ELECTRONICS FIELD CHANGE BULLETIN
NAVAL SHIP ENGINEERING CENTER, NAVY DEPARTMENT
WASHINGTON, D. C.

23-AN/URC-32
9-AN/URC-32A
14-KWT-6(8)

MODIFICATION OF FREQUENCY GENERATOR CV-731/URC
TO ACCEPT FREQUENCY CONVERTER CV-1749()/UR

PURPOSE: To modify the Frequency Generator CV-731/URC to accept the Frequency Converter CV-1749/UR. This will permit the Radio Set AN/URC-32() to be tuned in .1 KC increments.

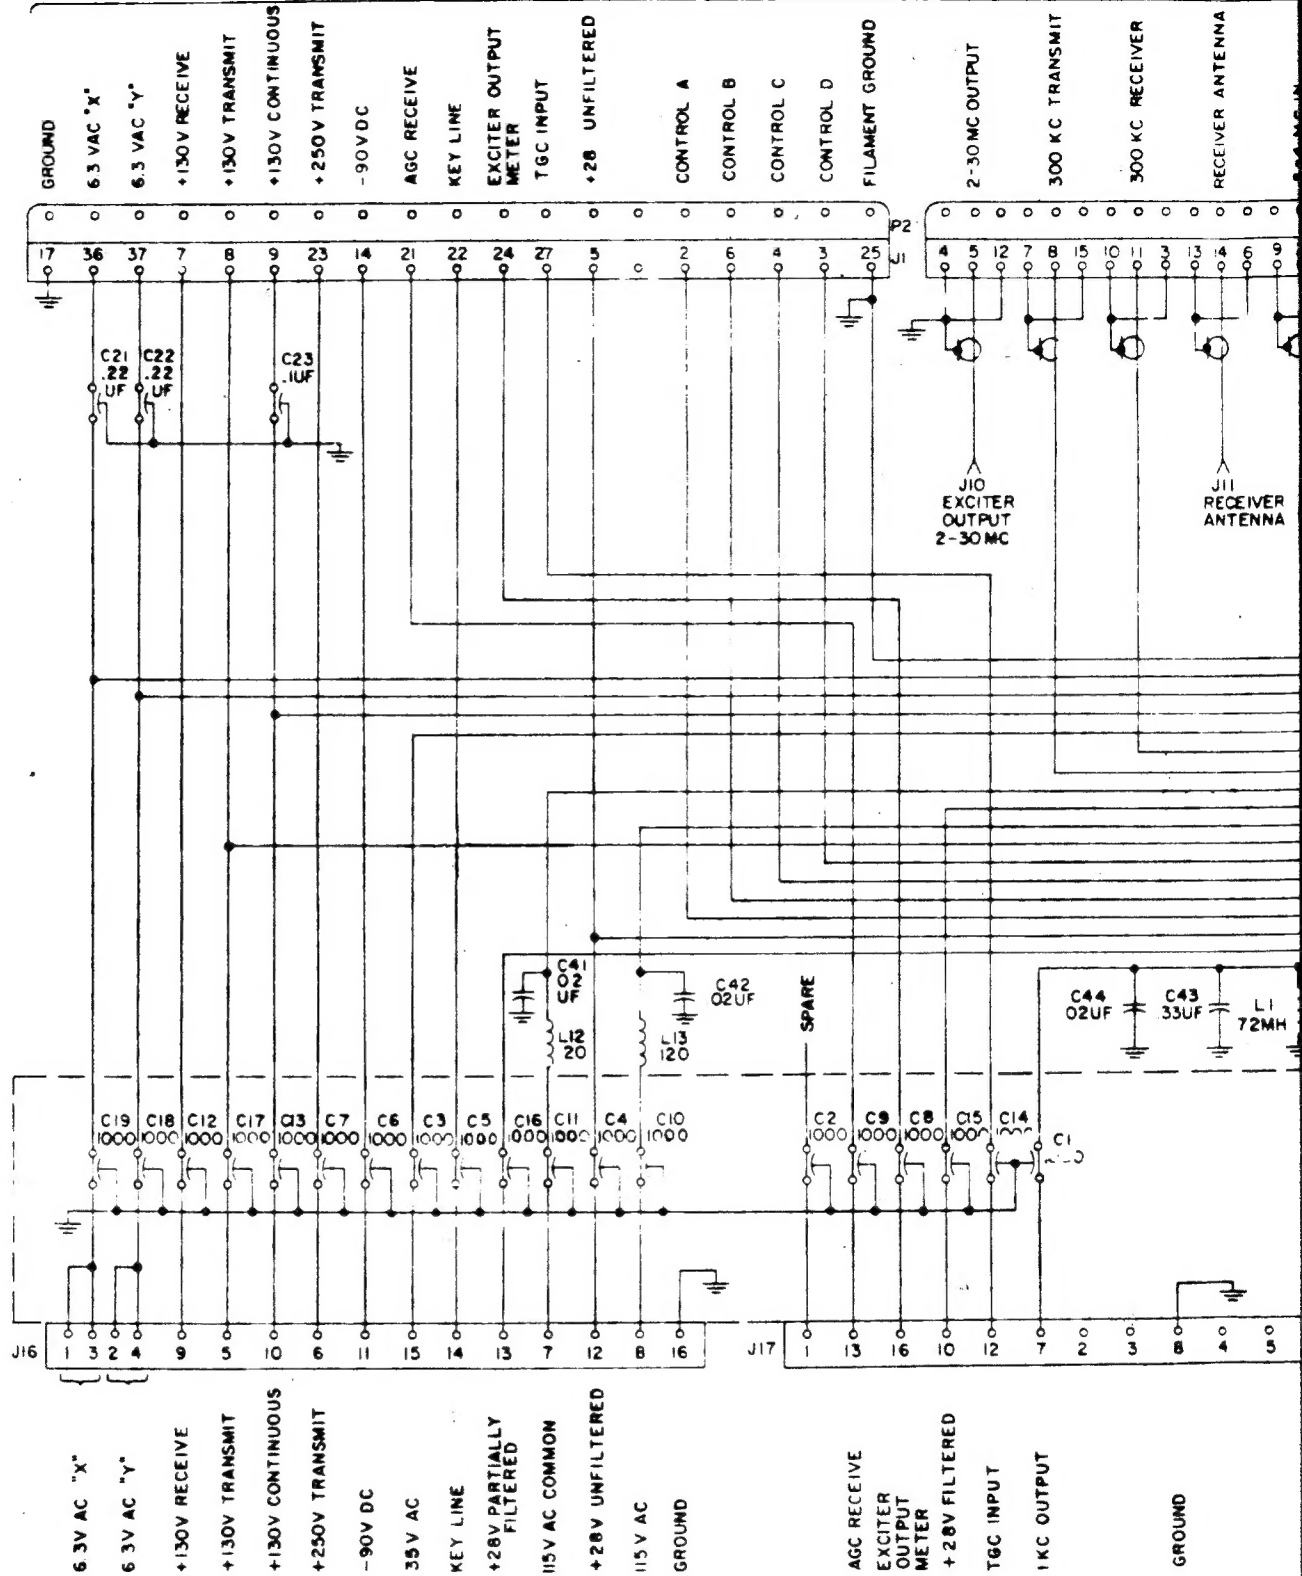
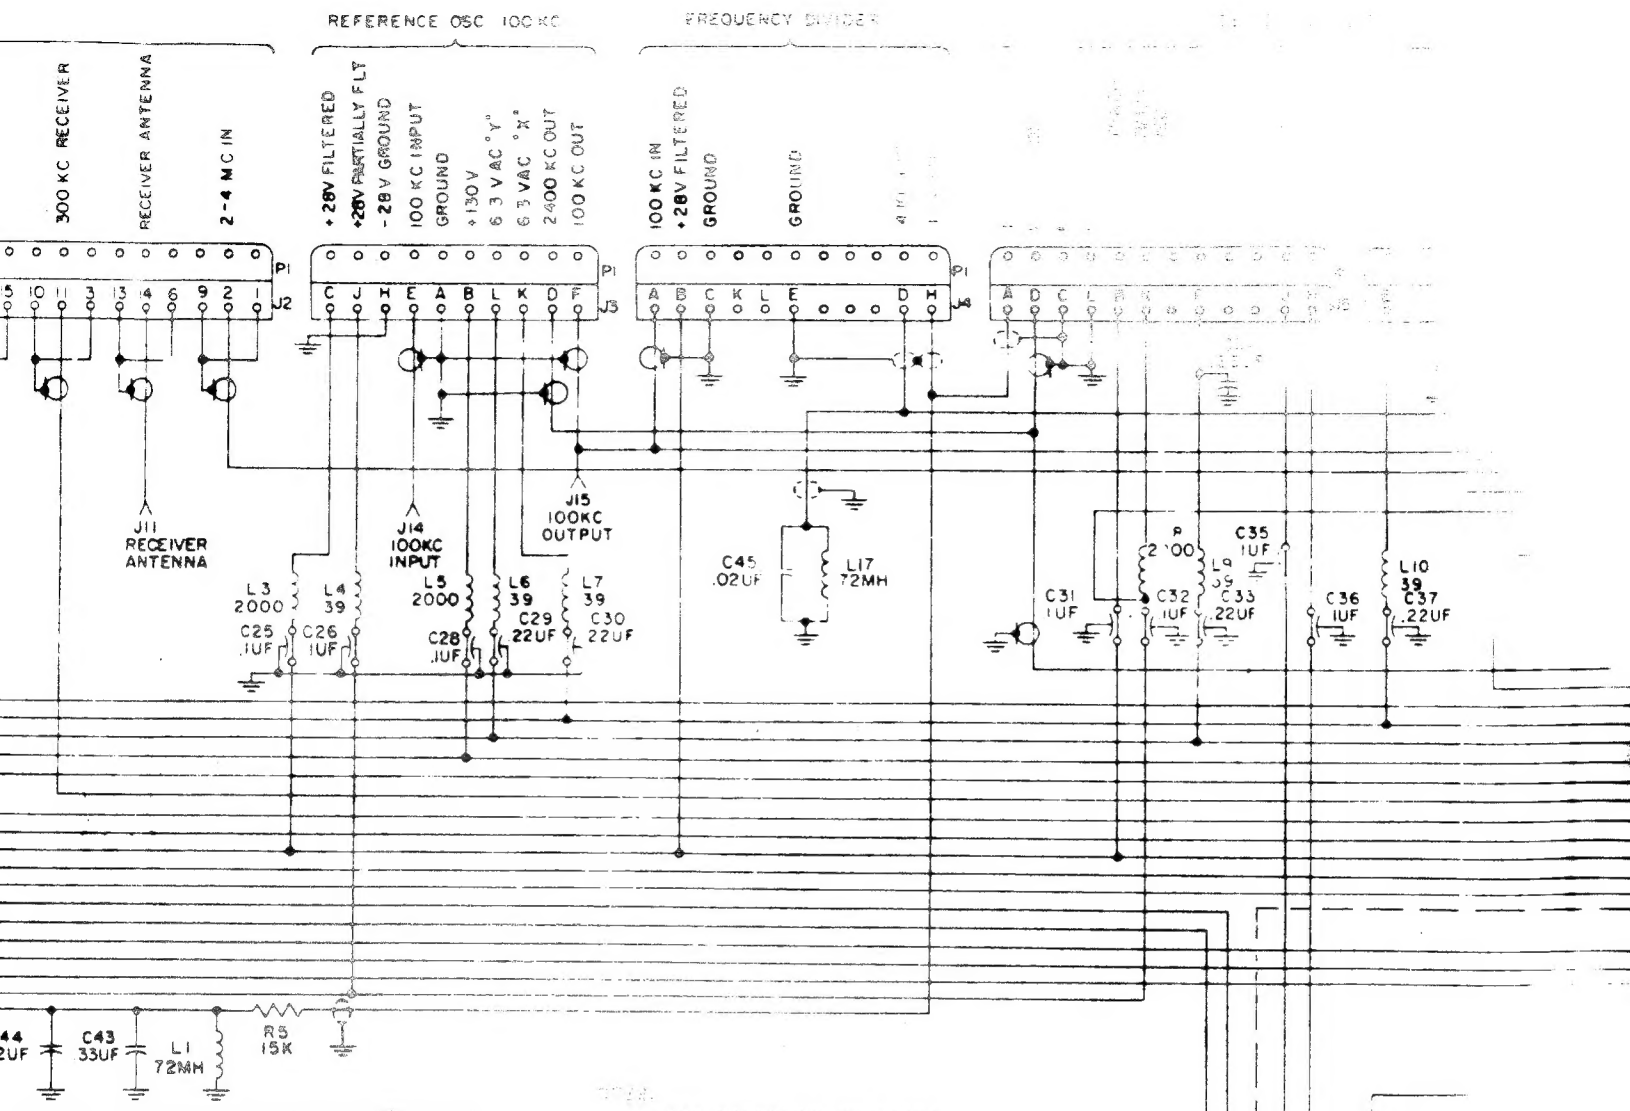
4. Figure 6 is a schematic of CV-1749()/UR. Figure 7 is a schematic of CV-731()/URC after this field change has been completed.

MOD 1 - ADD WIRE FROM PIN 15 TO
MOD 2 - MOD 5 - ADD C45 AND L17.
